REQUEST

Current Zoning: I-1 (light industrial)
 Proposed Zoning: I-2(CD) (general industrial, conditional)

LOCATION

Approximately 4.34 acres located at the end of Cressida Drive, near the intersection of South Boulevard and East Westinghouse Boulevard.
 (Council District 6 – Bokhari)

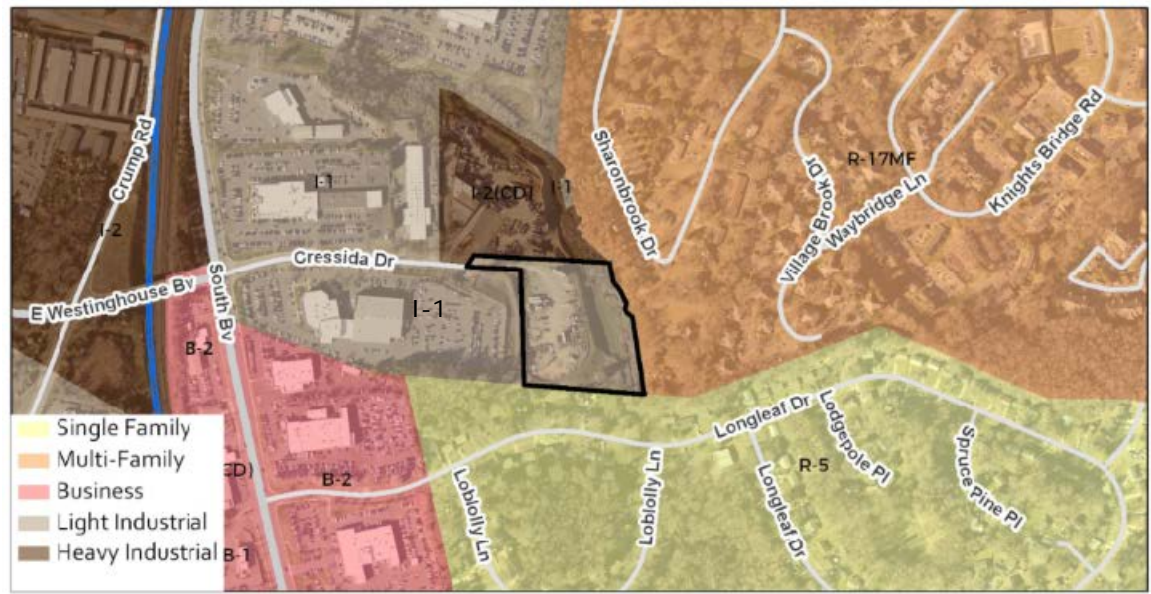
4. Remove the 10-foot setback/rear yard label from the site plan (top right corner) as the buffer line and building/parking envelope will take precedence. **Addressed**

5. Revise the site plan and conditional note(s) to include eight-foot planting strip and six-foot sidewalk on the frontage of the site not occupied by driveway(s). **Addressed**
